Planning - Case Comments

Project Number: PR-2024-011242

Application Number: SI-2025-00079

Project Name: 1401 Innovation Parkway SE- PNM (ESS)

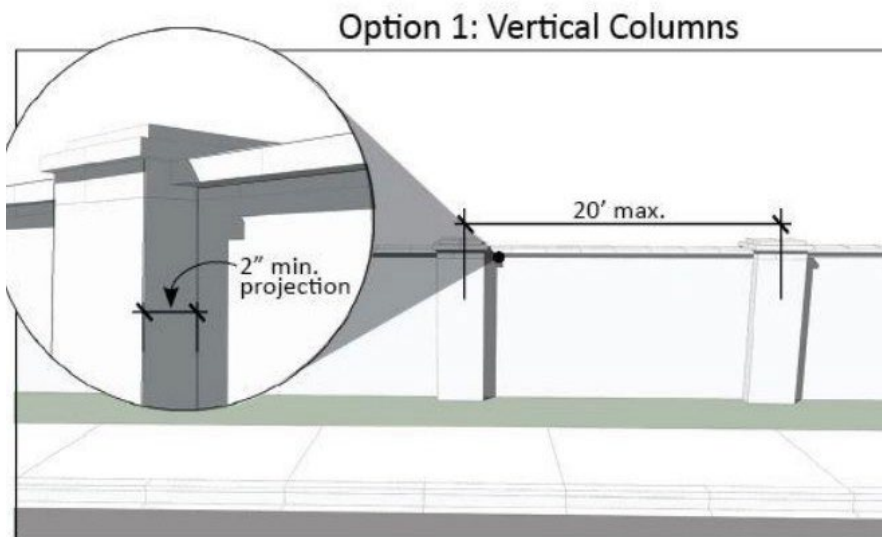
Portions of walls that obtain approval for a wall that exceeds the maximum height limits in Subsection 14-16-5-7(D) (Maximum Wall Height) **or are required to exceed those limits and that face any public street**, City park or trail, Major Public Open Space, or major arroyo, shall incorporate at least 1 of the following features to break up the massing of the wall. (See figure below for illustrations of each option).

Vertical pilasters with a minimum projection of 2 inches from the public side of the wall surface at intervals of no more than 20 feet in length. **This Site Plan is compliant with Option 1. As shown below.**

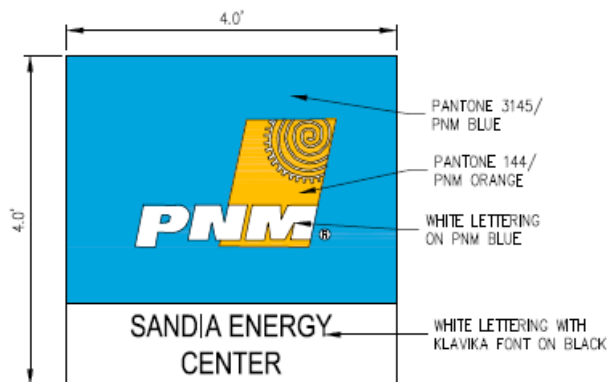
A permit will need to be obtained for the sign. Verify compliance with Sandia Science and Technology Park sign requirements per 6-5(G)(3)(c). Located on page 48 of the SSTP Master Plan. Link provided below:

PNM RESPONSE: PNM is aware of the necessary sign permit and will specifically reach out to SSA for approval on the sign. PNM does not wish to advertise the site, our overall goal it to have the site disappear behind the foliage and wall. Therefore and we do not intend on placing a large sign at the intersection of Gibson and Innovation defined the SSA master plan. There will be a smaller sign, mounted on the wall adjacent to the entrance gate only. This sign, as well as a the warning signs, are pictured on page 1 of the updated site plan.

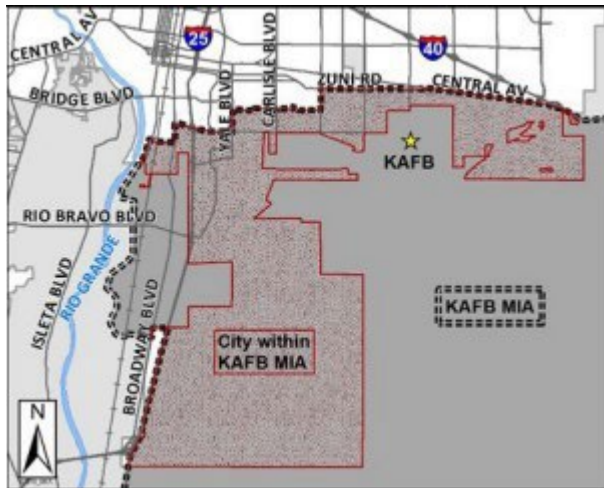
- **The subject property is located within the KAFB Military influence area per the map below and requires comments from the staff to be submitted.**
 - **PNM RESPONSE: PNM contacted the two known KAFB Community Planners and provided those communications to Planning staff.**
